**NOTIFICATION OF ADDENDUM
ADDENDUM NO. TWO
DATED: June 22, 2021**

PR South, Inc. on behalf of Northwest Williamson County Municipal Utility District No. 2

**Parmer Ranch, Phases 2, 3, & 4 Drainage, Paving, Wastewater and Water System
Improvements
City of Georgetown Williamson County, Texas**

Project Number:	22223/01
SCALE:	AS NOTED
Project Path:	P\22000-22999\22223
Project Name:	Parmer Ranch
Drawing Path:	Drawings\Plans
Xref DWG FILE:	
Sheet Number:	54 of 65 sheets

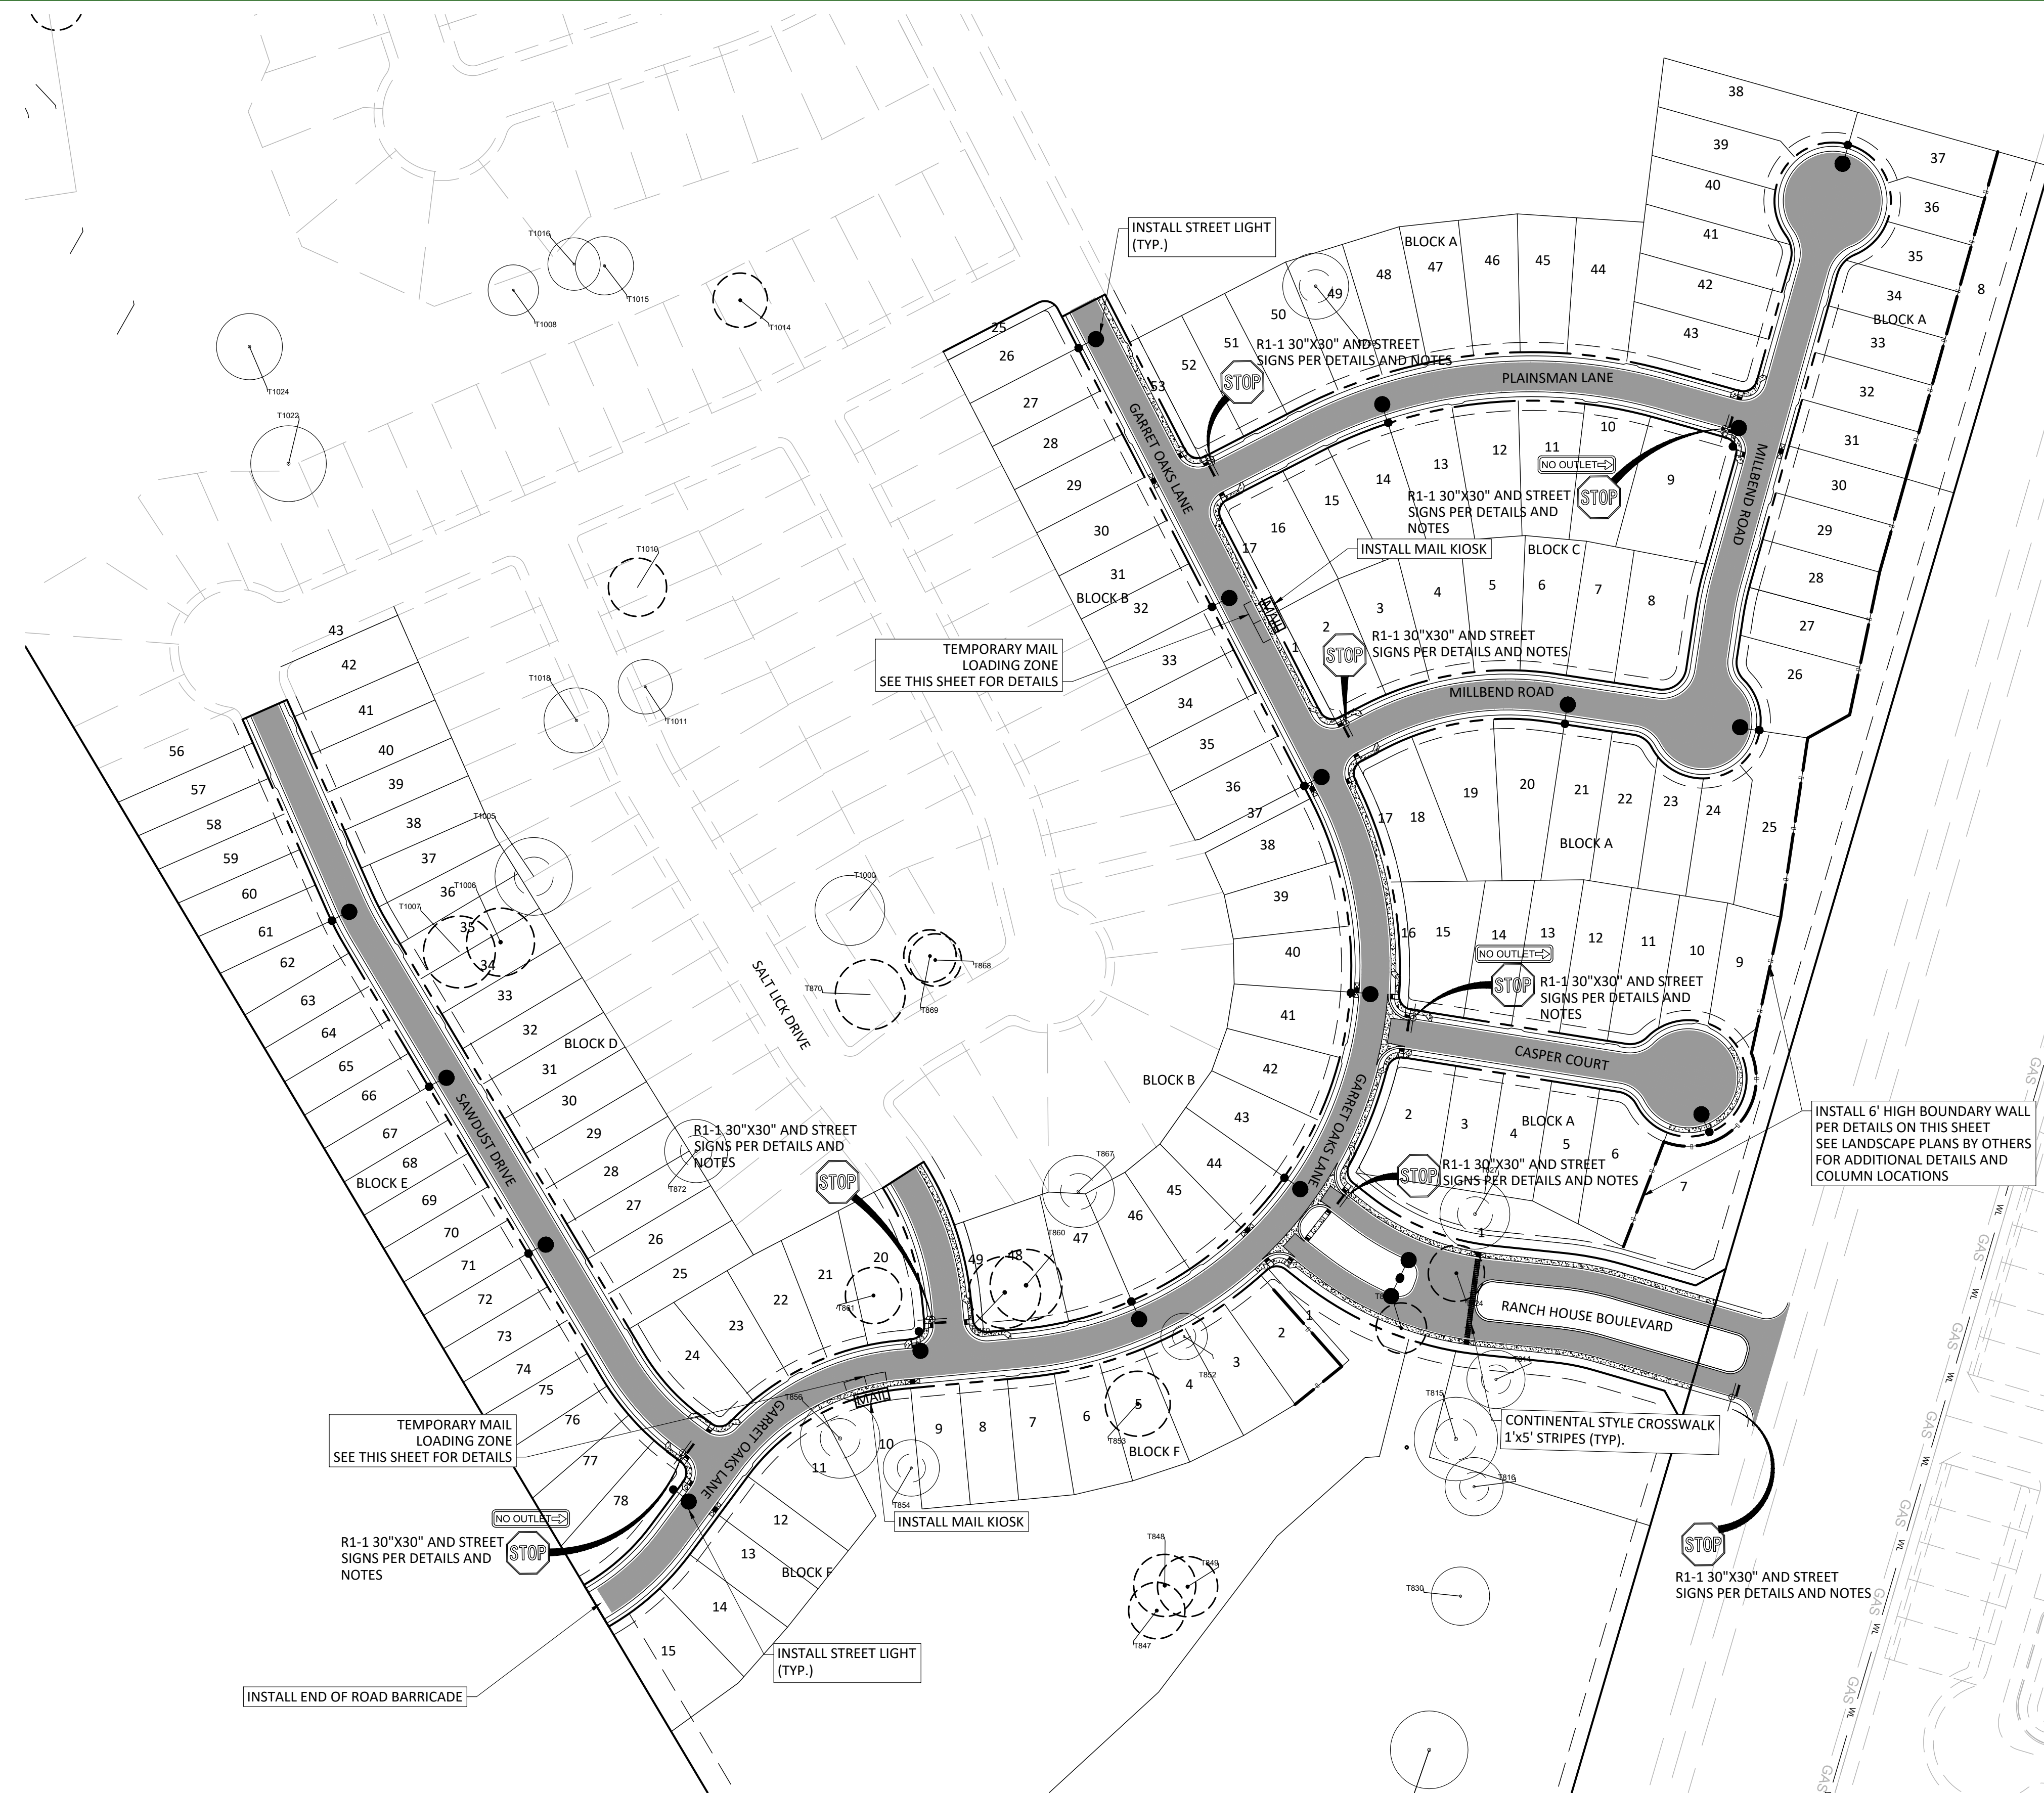
26. A large amount of your proposed street contours are not tying into existing. Can you clarify this discrepancy?
The grading plan has been updated and included with this addendum. CAD will also be send to all bidders who have returned CAD releases to our office as required.

Project Number: 22223/01
 SCALE: AS NOTED
 Project Path: P:\22000-22999\22223
 Project Name: Parmer Ranch
 Drawing Path: Drawings\Plans
 Xref DWG FILE:
 Sheet Number: 56 of 65 sheets

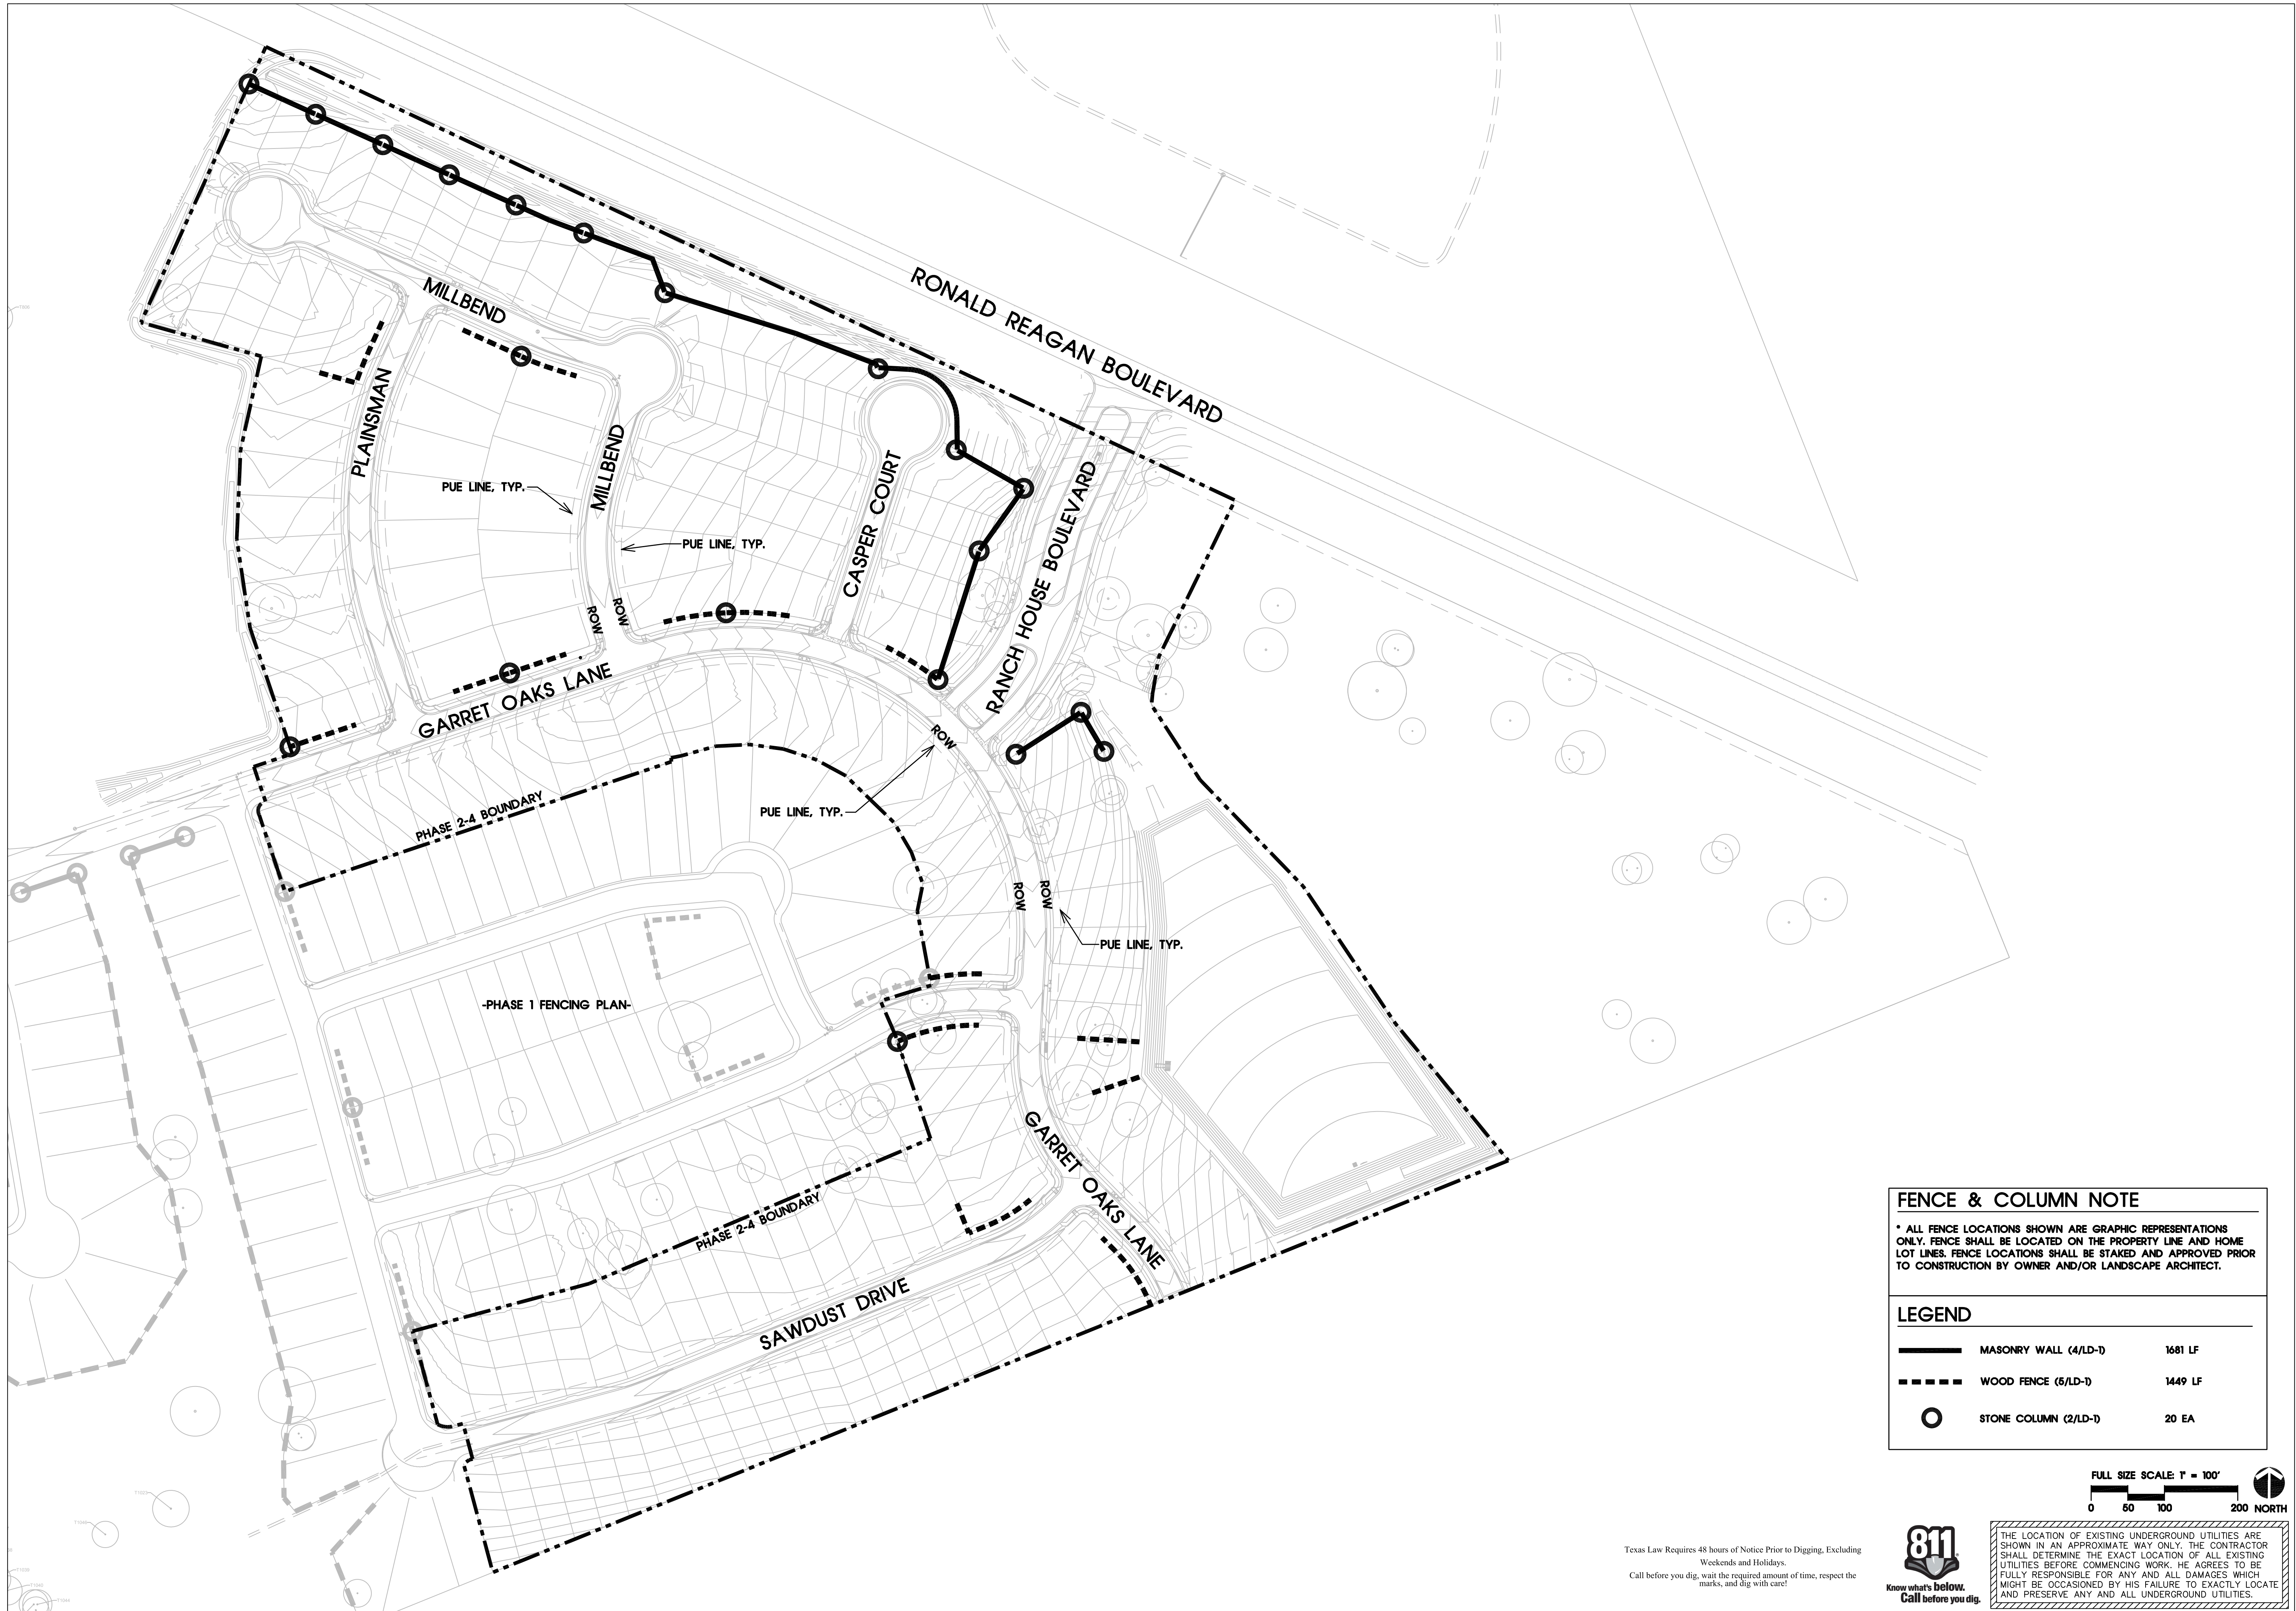
24. Are mail kiosks in our line of scope? There seem to be 2 called out on page 56 of the plan set but not noted in the bid form or anywhere else in the plan set.
Mail kiosks and pads are not a part of the scope of this project and will be included as part of the landscape package.

FENCING PLAN

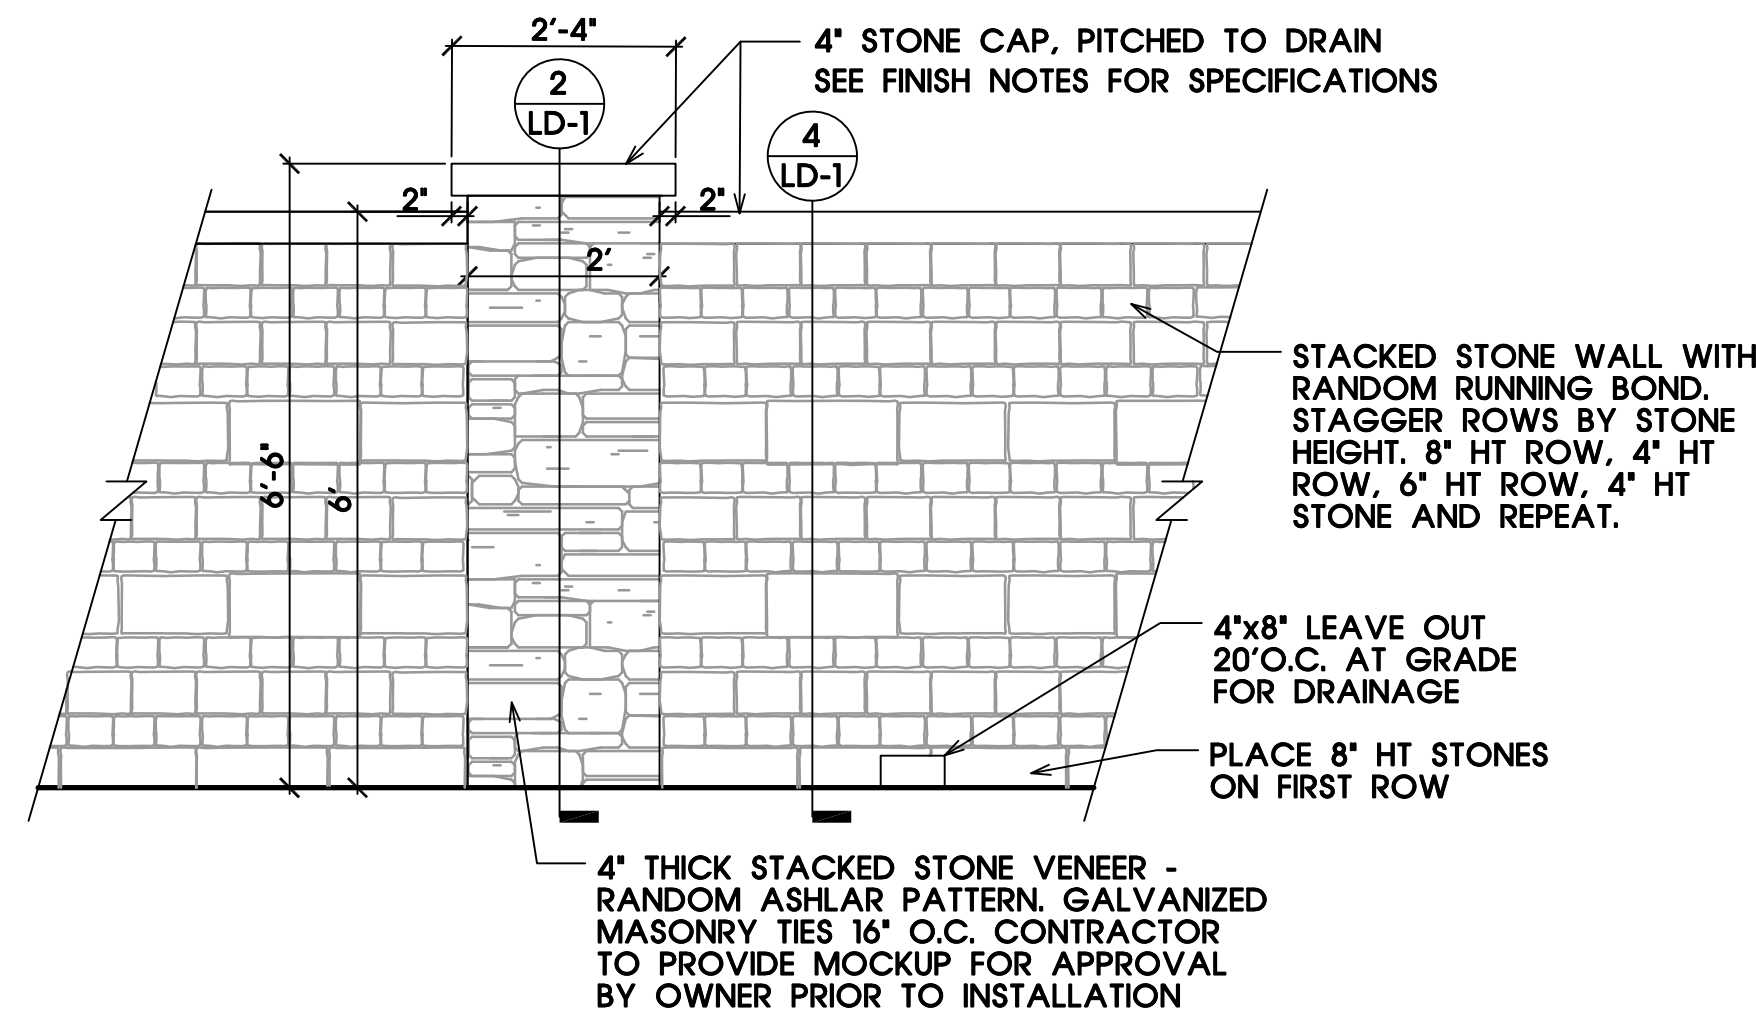
5. For the boundary wall, there is no spacing shown for the masonry columns. Can Steger Bizzell provide the spacing or give us the number of columns?
The Fencing Plan prepared for the project by SEC Planning has been included with the Addendum, which shows the locations of all walls and columns within these phases. The bid form has been updated to include an item for the columns and length of wall has been updated to include all wall and not just the walls required for regulatory approval of the plans. A bid item for wood fence has also been added. The columns, walls and wood fence shall be as shown and specified on the SEC Planning Fencing Plan and Details dated 6/18/2021 and included with the Addendum.
